**DURHAM CATHOLIC
DISTRICT SCHOOL BOARD**
Learning and Living in Faith

Subject: T26-12 New Kedron East Catholic Elementary School
Addendum No 1

Addendum Date: Friday, September 11, 2026

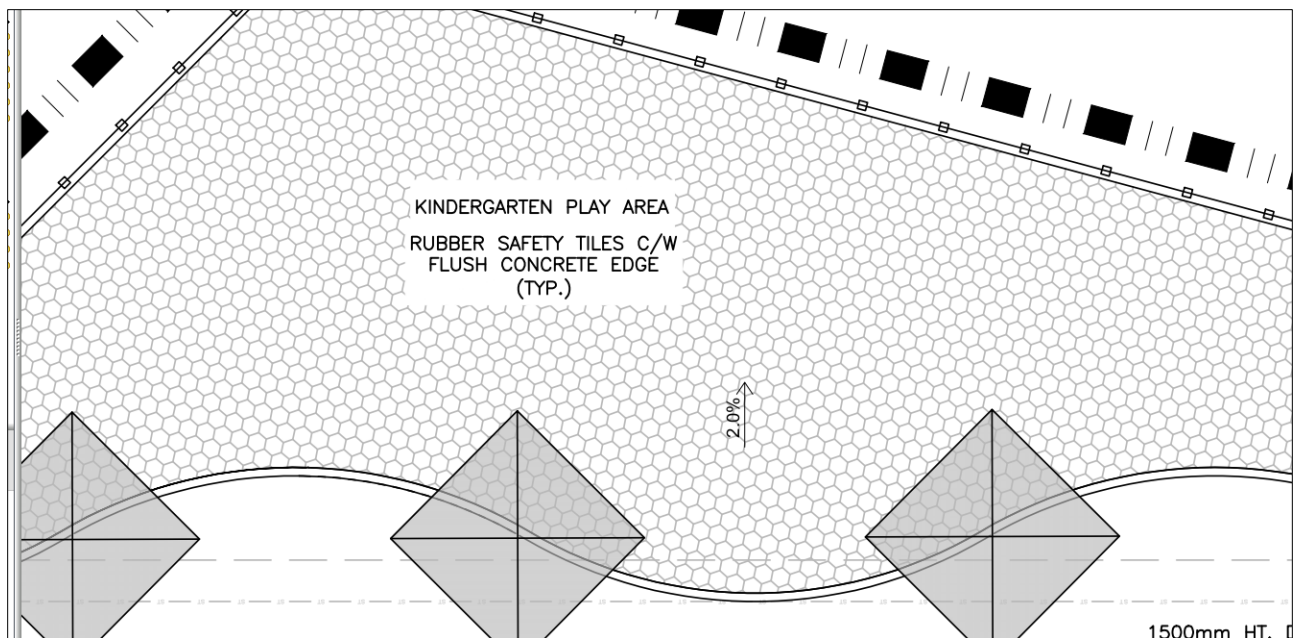
1. Please confirm, with the exception of the 3.0m wide asphalt multi-use pathways at the 2 site entrances, all other 3.0m Wide Asphalt MUPs to be installed by the developer and do not form part of this contract?
2. Referencing Alternative Price #8: Please confirm if this refers to ALL asphalt paving play areas including the pathways which lead to the armour stone seating areas and the asphalt apron at the Spec. ED. play area? (Please note, the kindergarten play area is just a small portion of the play areas at the back of the school and is specified as Rubber Safety Tiles and not heavy duty paving.)

1. Confirmed.
2. Alternate Price #8 refers to the asphalt area (not rubber safety tiles) in the Kindergarten play area only.
